Subject: Response to Closure Requirements and Work Plan for Additional Groundwater Remediation
in TCA Filling/Parking Lot Area
Tecumseh Products Company, Grafton, Wisconsin

Response to Closure Requirements and Work Plan for Additional Groundwater Remediation in TCA Filling/Parking Lot Area

Subject: Closure request for groundwater, Tecumseh Power Co, 900 North Street, Grafton, file reference FID #246009170, BRRTS #0246000751.

FIGURE 1

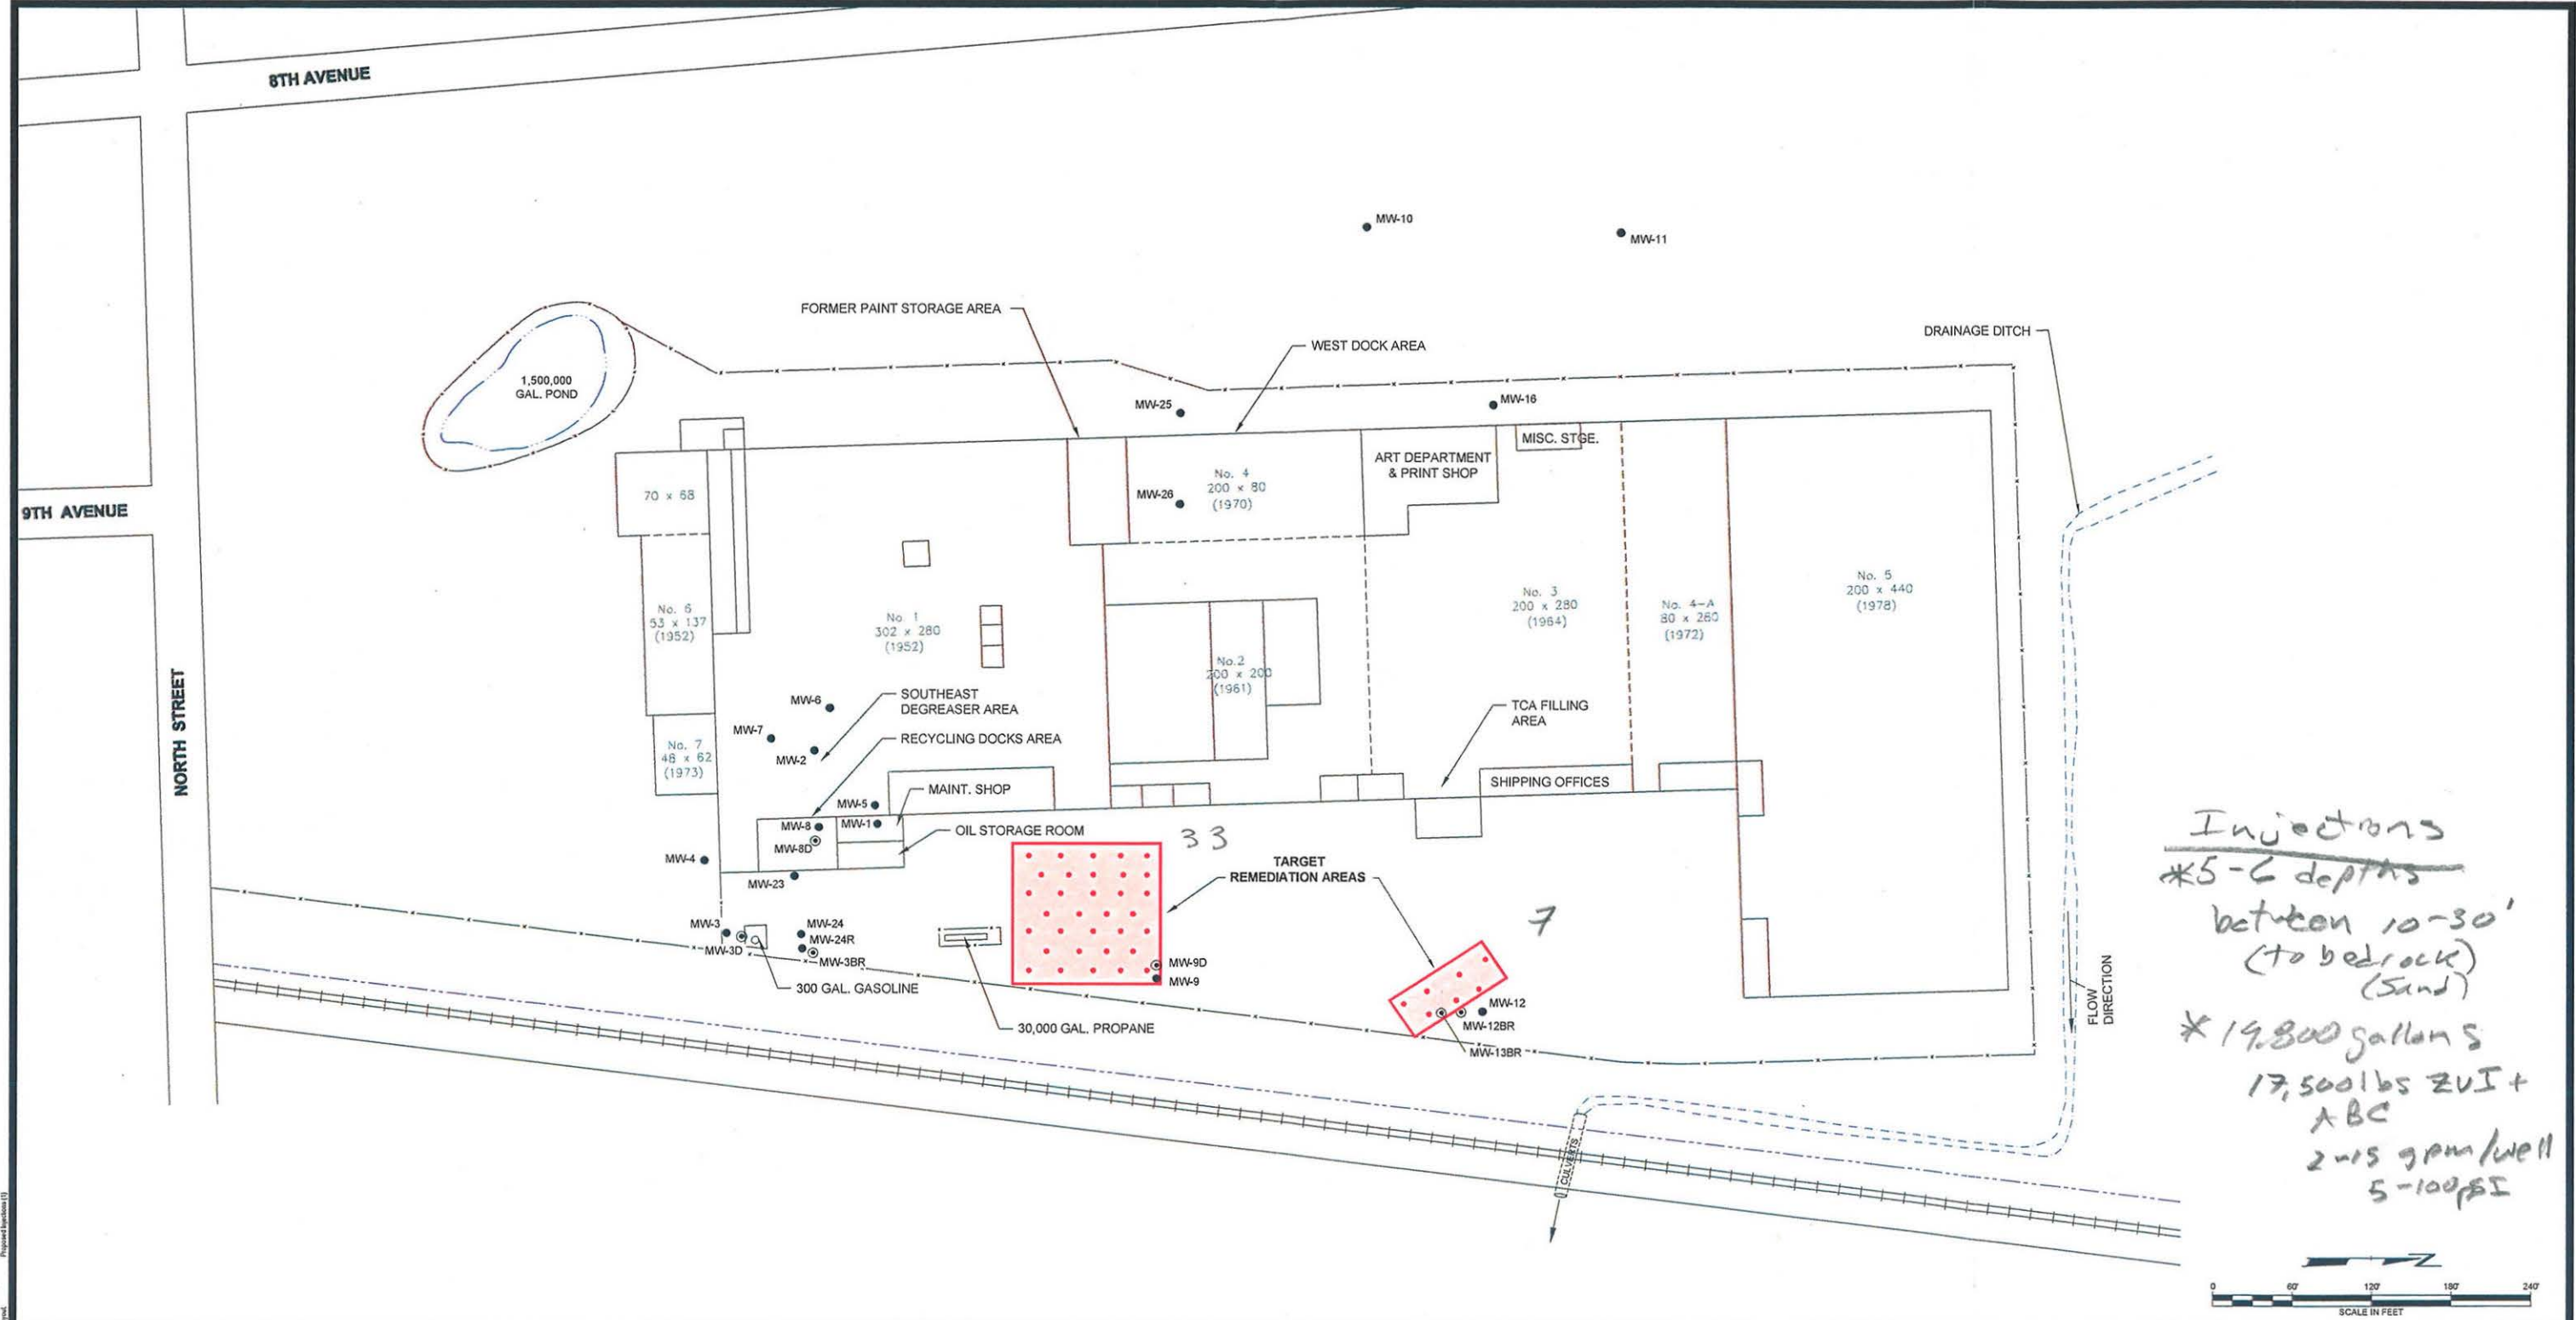
Handwritten notes:
 Injections
 *5-6 depths
 between 10-30'
 (to bedrock)
 (sand)
 *19,800 gallons
 17,500 lbs ZVI +
 ABC
 2-1/2 gpm/well
 5-100 PSI

FIGURE 5-1
 RECOMMENDED UTILITY MASTER PLAN
 WATER SYSTEM STUDY
 GRAFTON WATER AND WASTEWATER UTILITY
 DEC 2001 39210

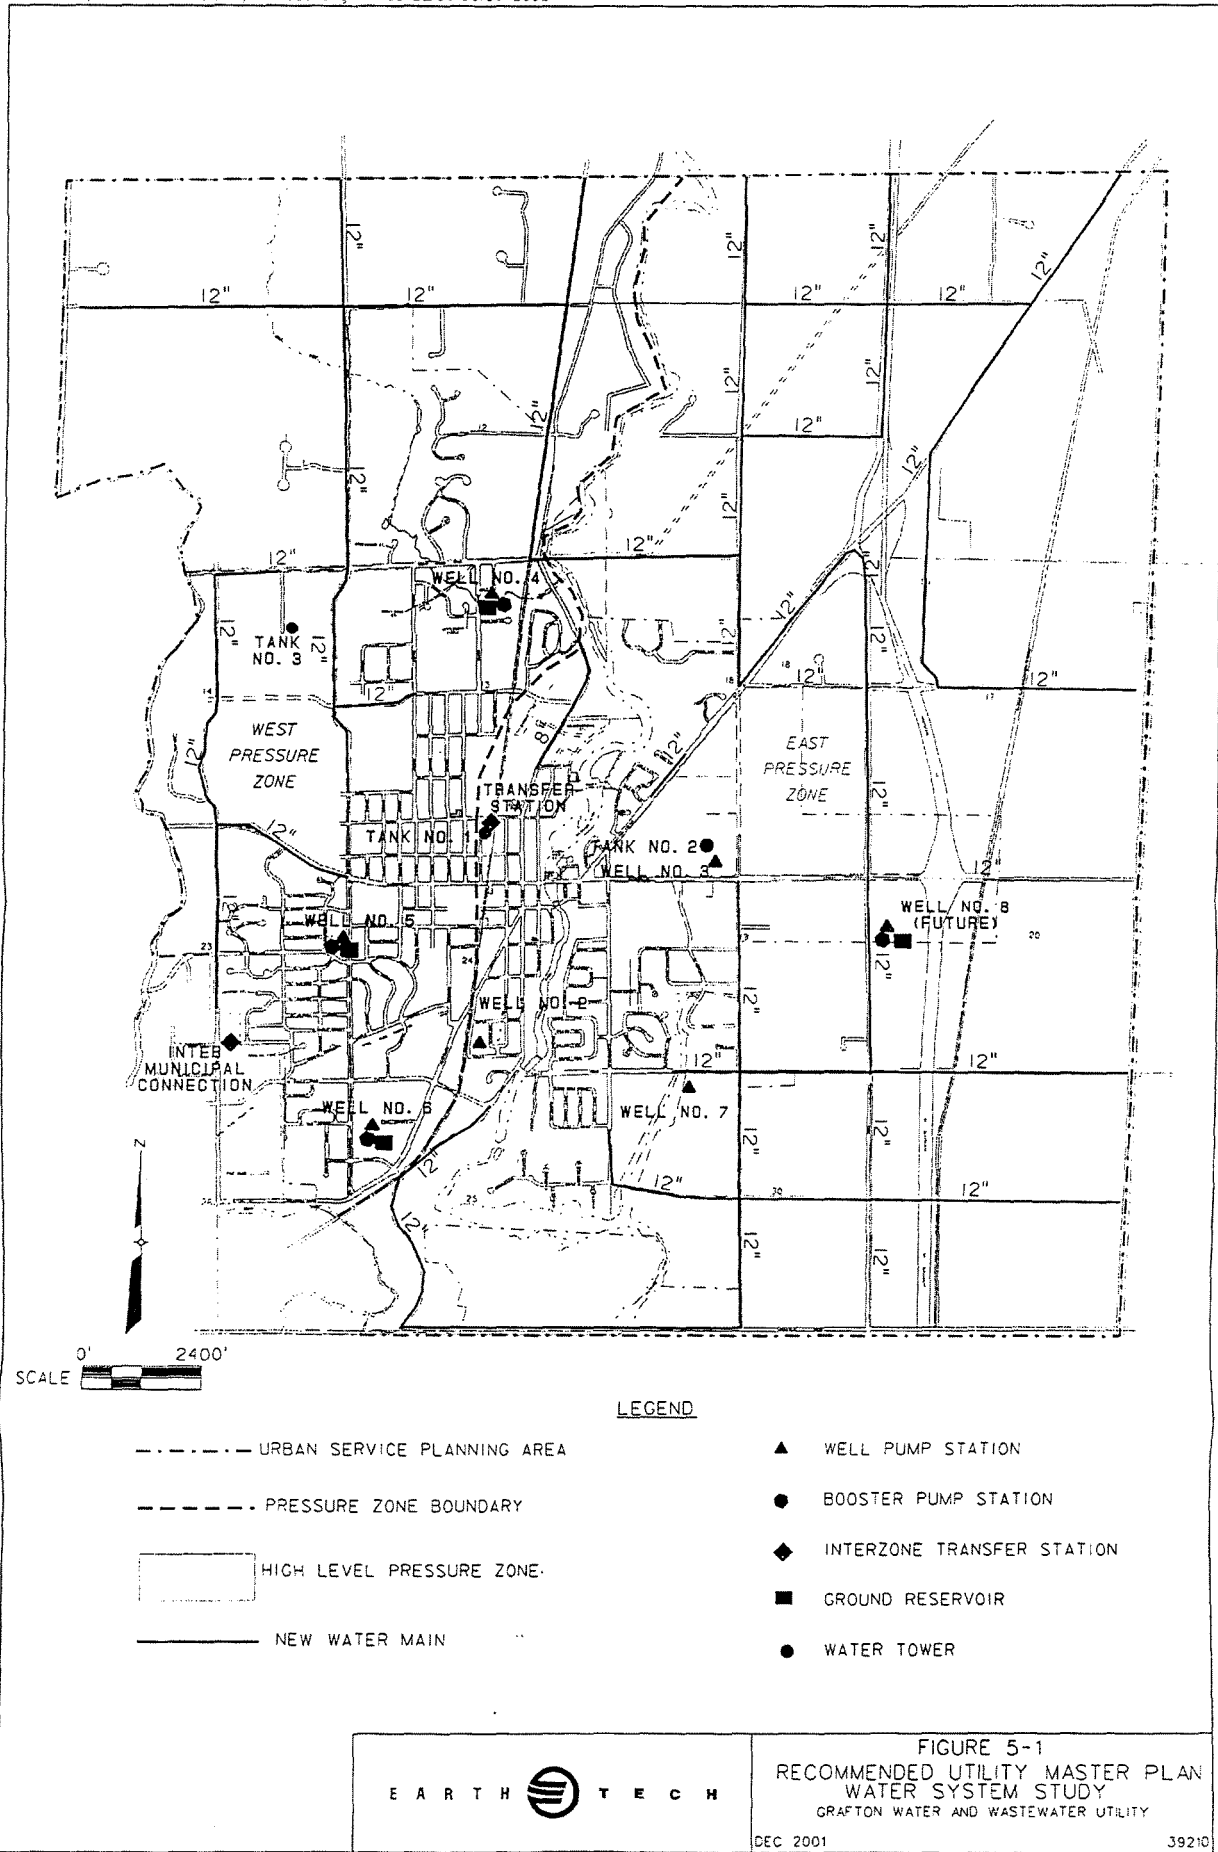
includes service area?

The current municipal water supply well map was obtained from the Village of Grafton and is included in Appendix D. ☆
